COMMUNITY DEVELOPMENT DEPARTMENT REPORT

HEARING 2/24/26
DATE: *Continued from: 5/6/25, 8/12/25,
9/16/25, 1/13/26*

SUBJECT: [H-2024-0059](#)
Latitude Forty Three Subdivision – AZ,
PP

Annexation of 17.27-acres of land with R-8 (13.78-acres), R-15 (2.42-acres) and C-N (1.07-acres) zoning; and Preliminary Plat to re-subdivide Lots 7, 21 and 22, Magic View Subdivision Amended into 79 residential lots, 1 commercial lot and 11 common/other lots on 15.97-acres of land in the R-8, R-15 and C-N zoning districts.

E. Common Driveway Exhibit

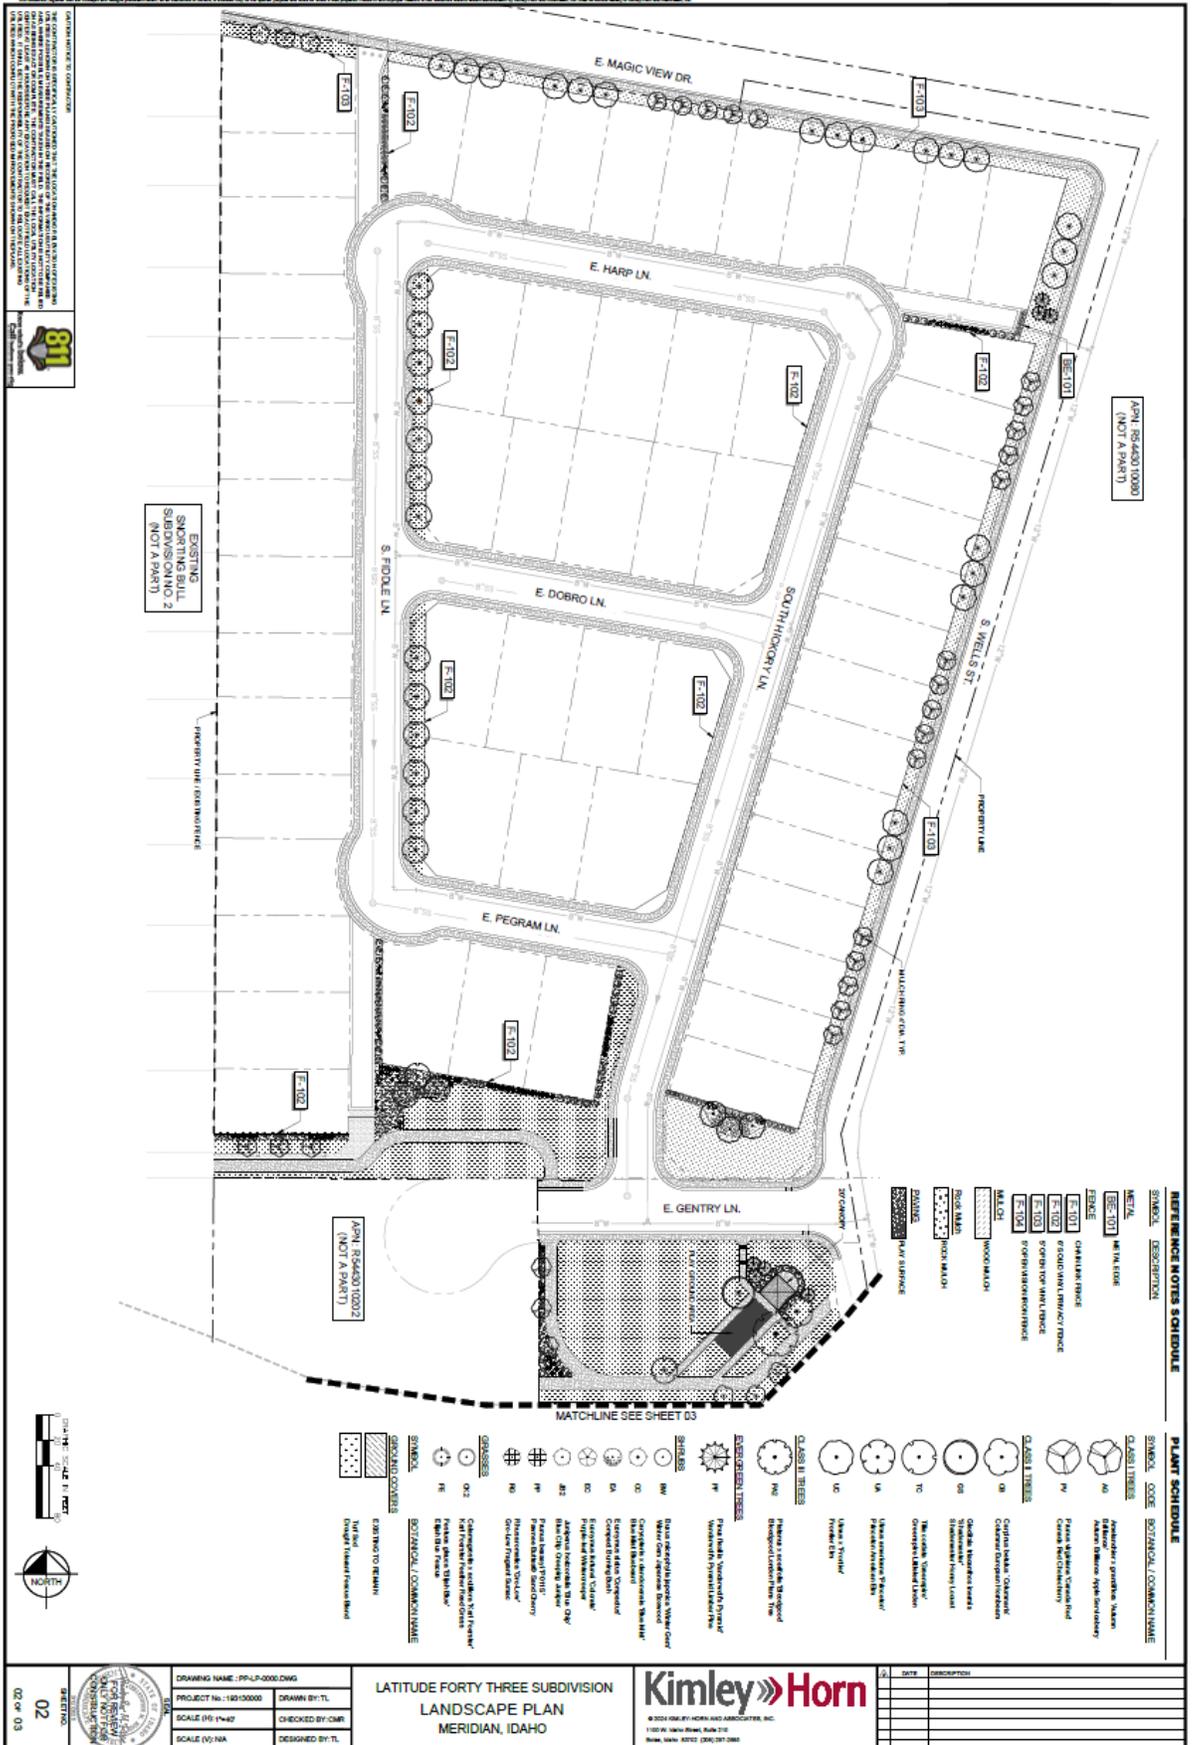
Common driveways: Three (3) common driveways are proposed, which are required to comply with the standards listed in UDC 11-6C-3D. Common driveways should be paved with a surface with the capability of supporting fire vehicles and equipment. A common driveway exhibit is included in Section VII.E below that depicts the setbacks, building envelope and orientation of the lots and structures.

- xiv. Remove the sidewalk along the west side of S. Longitude Dr. and provide right-of-way to the west property line.
4. The common driveways shall be constructed in accord with the standards listed in UDC 11-6C-3D and building setbacks shall be as shown on the common driveway exhibit in Section VII.E.

I. Fivemile Creek Cross-Section & Photo

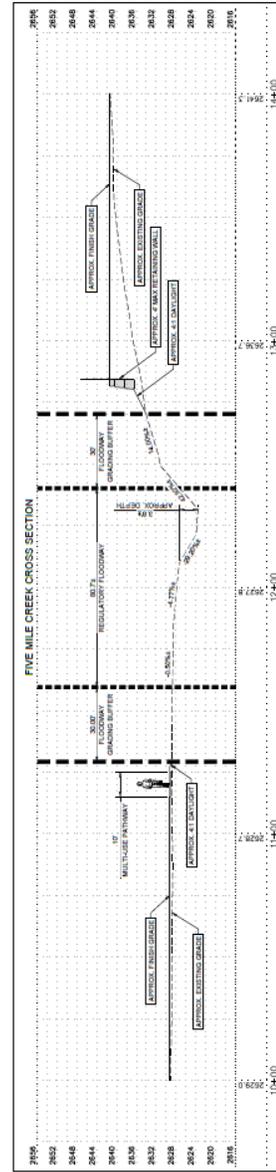
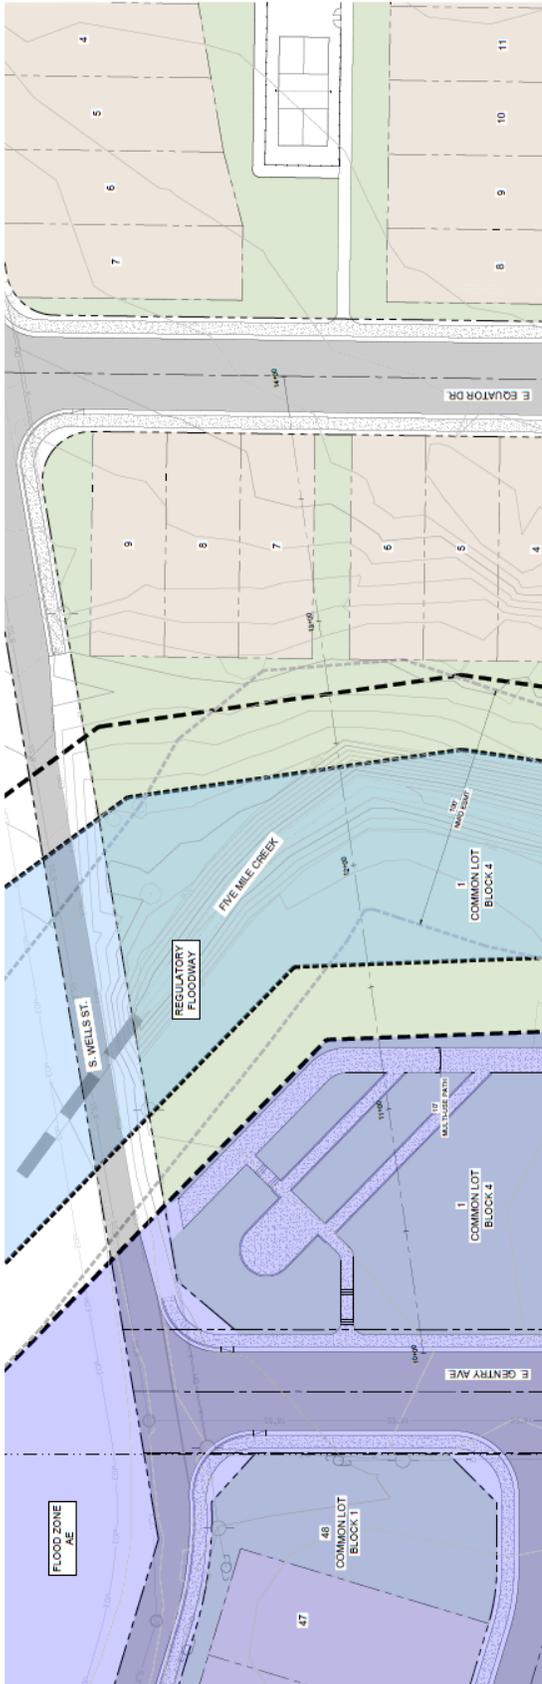
The Fivemile Creek bisects this site. A cross-section and photo of the creek is included below in Section VII.I, which depicts the approximate existing and finished grade on both sides of the creek, the slope and a 4' tall retaining wall on the south side of the creek. The slope on the north side is approximately 3:1, which meets the accessibility and maintenance standards for stormwater facilities in UDC 11-3B-11C.6 of a 3:1 slope or less – Staff recommends the north side remain open and not be fenced. The slope on the south side is approximately a 4:1 slope, which exceeds acceptable accessibility and maintenance standards – Staff recommends the south side is fenced with a 6' tall wrought iron fence for public safety in accord with UDC 11-3A-6C.3, unless the slope can be modified to 3:1 or less, in which case the creek should be accessible and not fenced. Council should consider Staff's recommendation and determine if it is appropriate.

Per UDC 11-3A-6C.1, fencing along all natural waterways shall not prevent access to the waterway. In limited circumstances and in the interest of public safety, larger open water systems may require fencing as determined by the City Council, Director and/or Public Works Director. A cross-section and photo of the creek is included below in Section VII.I, which depicts the approximate existing and finished grade on both sides of the creek, the slope and a 4’ tall retaining wall on the south side of the creek. Approximately a 3:1 slope is shown on the north side of the creek. Because the slope on the north side meets the slope requirements in UDC 11-3B-11C.6 for accessibility and maintenance of stormwater facilities of 3:1 or less, Staff recommends this side remain open and not be fenced in accord with UDC 11-3A-6C.1 but recommends a 6’ tall open vision wrought iron fence is installed along the south side of the creek for public safety since the slope in that area exceeds acceptable standards for accessibility *unless* the slope can be modified to be 3:1 or less – Council may determine otherwise.

The Fivemile Creek, a natural waterway, bisects this site within a 100' wide easement and should remain open and be protected during development. Building lots do not and should not encroach within the easement. A cross-section of the creek is included in Section VII.I below that shows the approximate existing and finished grade on both sides of the creek, slope and a 4' tall retaining wall on the south side of the creek.

- xi. Remove the fencing depicted along the north side of the Fivemile Creek and depict 6-foot tall wrought iron fencing along the south side of the Fivemile Creek for public safety, unless otherwise modified by City Council.
